# HPF invited

**International competition on the Future Art Building in the Orestad. 7 teams invited. Entry by PUSH / Christophe Cornubert with Abbie Chung, Grace Lau, Robert Sumrell, Merisa Dewa and Tine Østergaard**

## The jury's report:

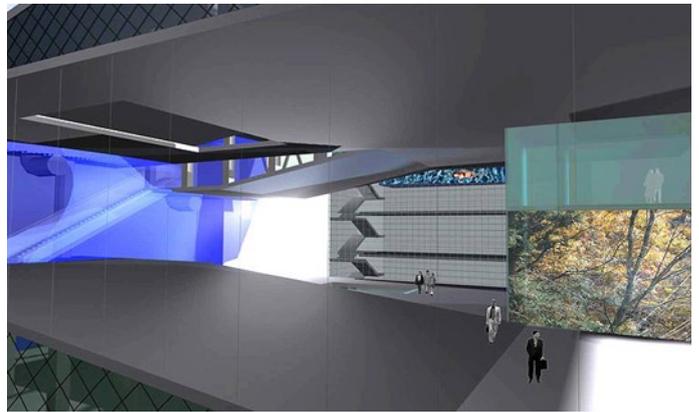
The “playground” on level two, column-free and less subject to physical changes, offers more immaterial methods of occupation and transformation, while apparently presenting a spectacular view of the landscape of the Ørestad.

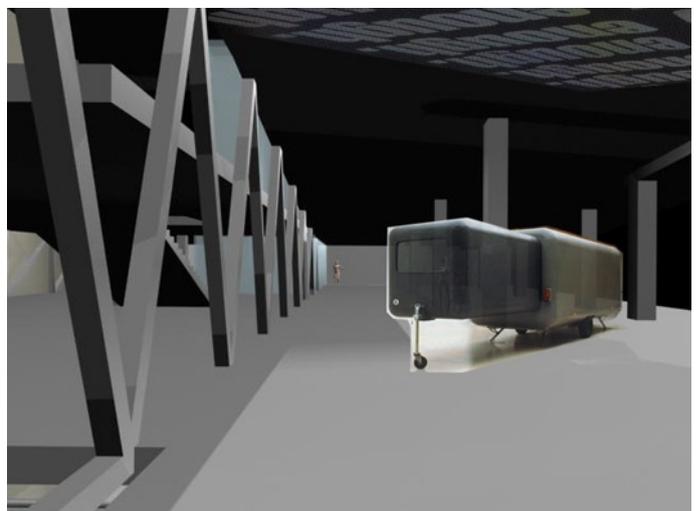
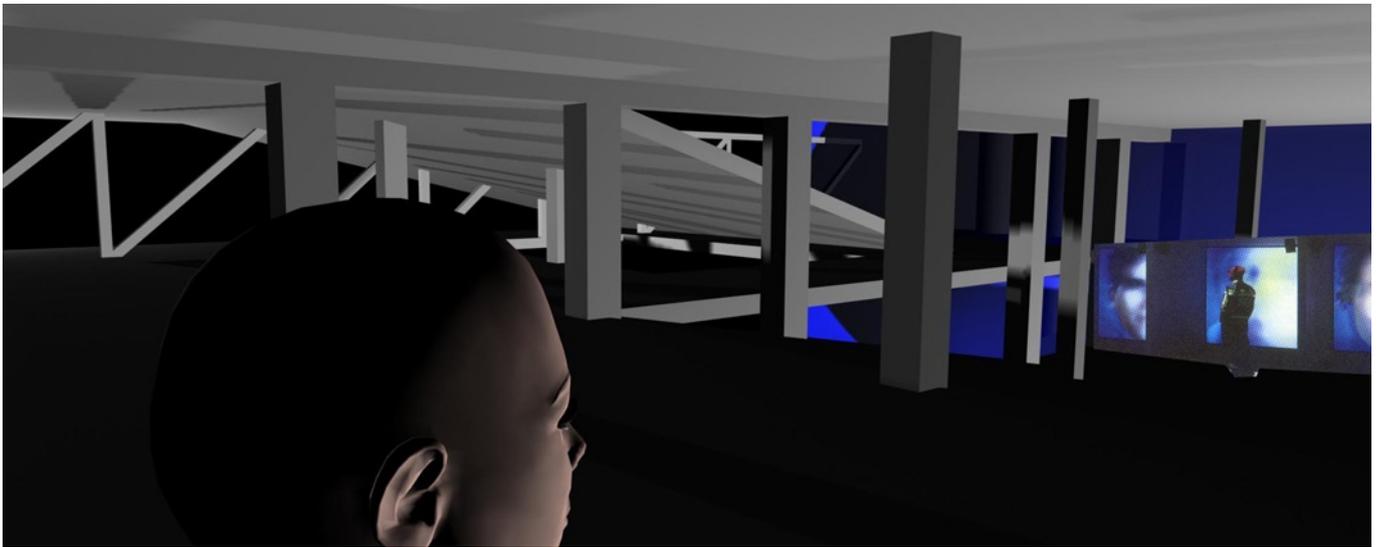
The main event space is of a suitable size for theatre and exhibition, though details of the infrastructure proposed for lighting, sound, data and video are not described clearly. Control of the space similarly is undeveloped, though a system of screens and curtains is suggested as a means of achieving blackout. There is no discussion of sub-dividing the space and the layout options given for theatre presentations are limited to traditional configurations. Furthermore, the lack of information on how the space may be divided creates a difficulty in understanding how the venue may still be programmed during periods of devising and rehearsal. If the “infrastructural plenum” illustrated is intended as a control position for lighting and sound, it seems to be at the wrong end of the space. The design also omits to allocate any spaces as dressing rooms for artists.
